# SR/CR A1A PEDESTRIAN SAFETY & MOBILITY STUDY

## PEDESTRIAN / BICYCLE SAFETY REVIEW

Focus Area E / Sandcastle Drive to Holland Road (Ormond Beach/Ormond-by-the-Sea)

## **Pedestrian/Bicycle Safety Review Report for Focus Area E: SR A1A from Sandcastle Drive to Holland Road (Ormond Beach/Ormond-by-the-Sea)**

Figure 13

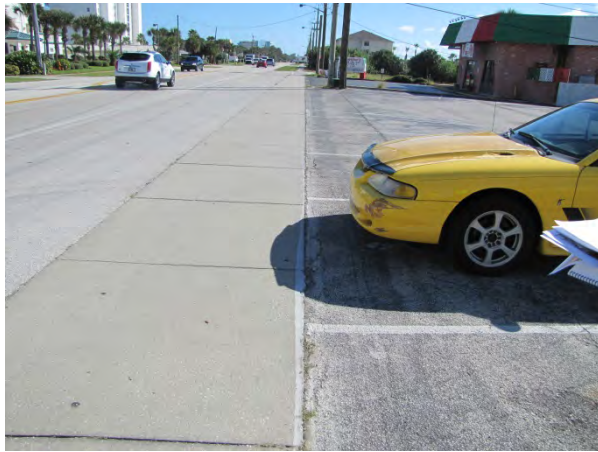
As illustrated in **Figure 13** and **Figure 14**, multiple parking areas to commercial properties do not have defined driveways and allow access to their parking spaces for the entire width of the parcel. This issue introduces numerous unexpected conflict points for bicyclists and pedestrians to negotiate. Some sites do not have sufficient set-backs to allow for onsite circulation for parking maneuvers. The study team identified multiple locations where parked vehicles in these areas encroached onto sidewalk facilities as illustrated in **Figure 15**.

For parcels with the ability to facilitate onsite circulation of parking maneuvers, consider working with the private property owner to install wheel stops or curbing to direct motorists to access SR A1A via defined driveway locations only.

For parcels without the ability to facilitate onsite circulation of parking maneuvers, consider relocating parking to areas with better parking access and circulation.

Some parcels may not have the ability to relocate parking areas. However, many of these parcels are located in areas with wide shoulders; implementation of complete streets strategies (**Issue #1: Speed Consistency**) could allow for opportunities to right-size the motorist, bicyclist, and pedestrian facilities and reduce conflicts between bicyclists and pedestrians with parking motorists while making use of available space indicated in **Figure 14**.

**Figure 20**

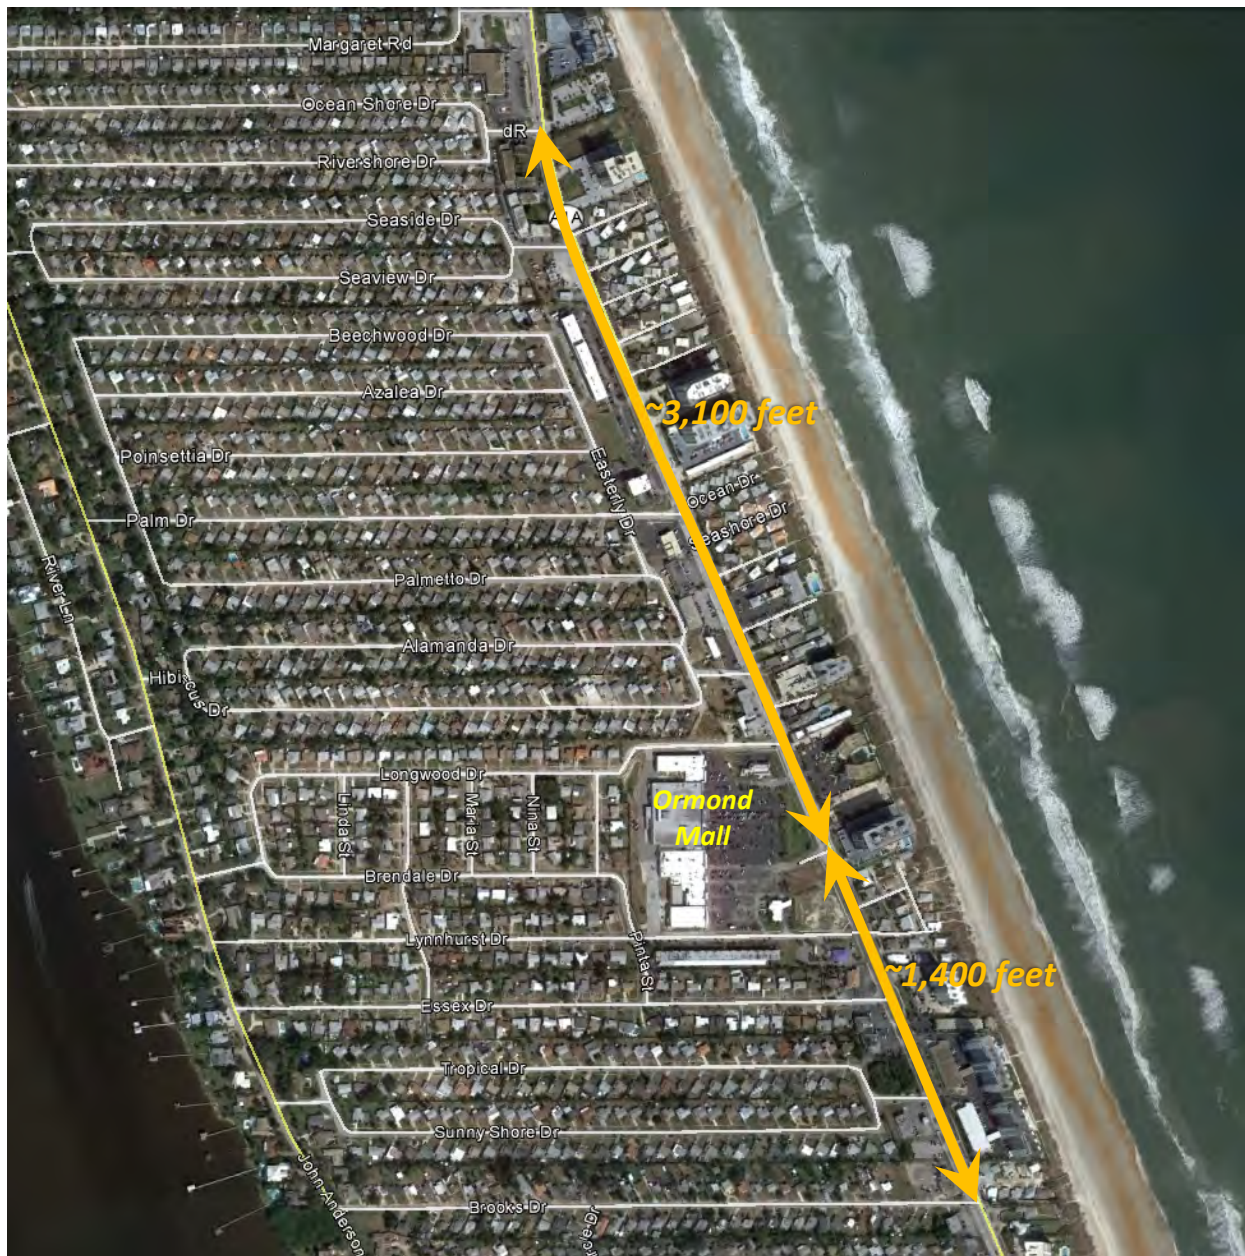
Sidewalks are provided on both sides of Essex Drive, but do not connect to the sidewalks along SR A1A.

Consider installing sidewalks or designating a clear pedestrian access route (PAR) compliant with the PROWAG.

Figure 33

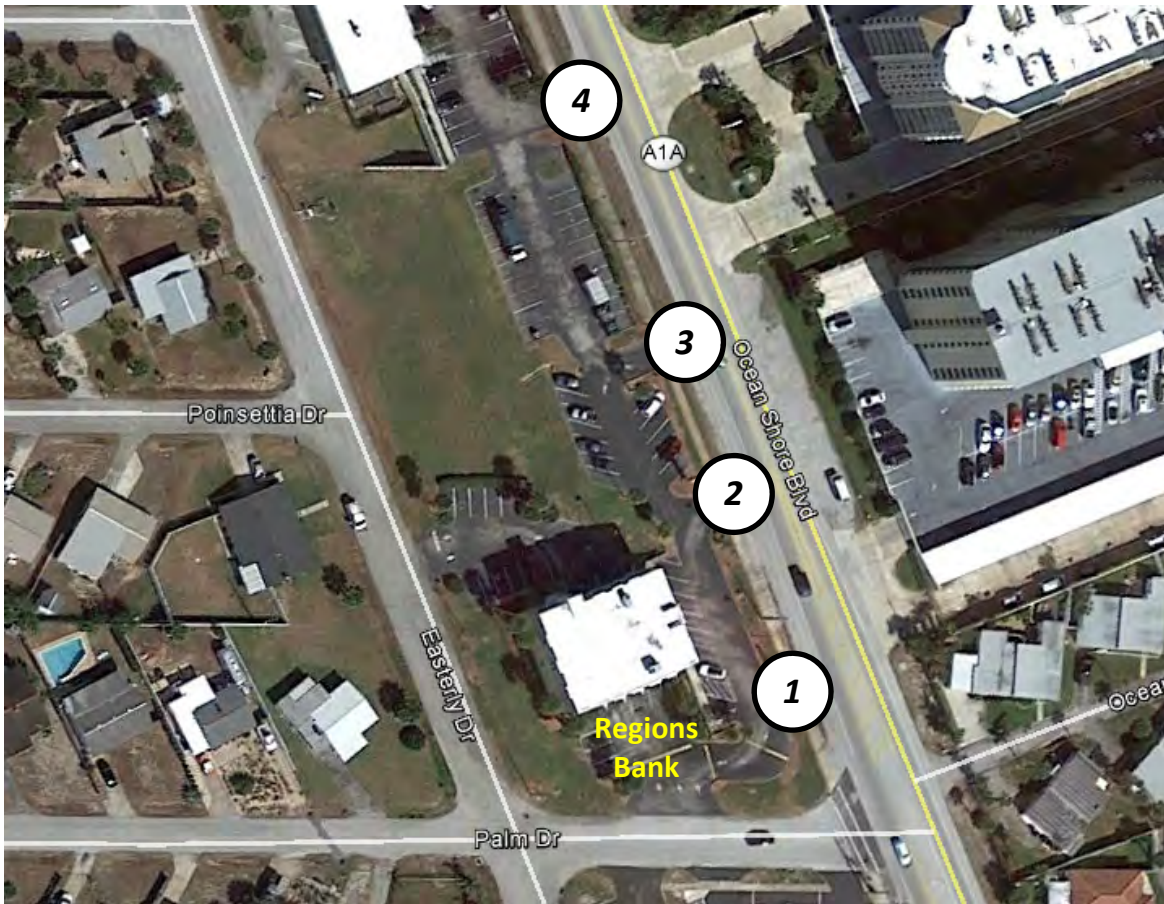
The Regions Bank has three exclusive driveways on SR A1A and shared access to an additional driveway just north of the site, for a total of four access points to SR A1A (see **Figure 33**). The site also has driveways on Palm Drive and Easterly Drive. Driveways are conflict points between pedestrians/bicyclists utilizing the sidewalk and vehicles exiting the property or turning from SR A1A. The higher the number of driveways along a corridor, the higher the potential for crashes between a pedestrian/bicycle utilizing the sidewalk and a vehicle exiting/entering a property.

As shown in **Figure 34**, driveway crossings at this location have asphalt mounded up where the sidewalks connect.

To address the same property, multiple driveways issue, consider driveway consolidation during potential redevelopments where feasible. For currently undeveloped properties, consolidating these driveways during redevelopment will reduce the amount of conflict areas between pedestrians/bicyclists and vehicles. Some local government agencies around Central Florida have incorporated land use policies encouraging pedestrian cross access between adjacent commercial and office properties. Cross-access between adjacent parcels within a block should be a focus on the SR A1A corridor as properties redevelop which would help eliminate unused or underutilized driveways.

Consider grinding potential trip hazards along the corridor as part of regular maintenance.
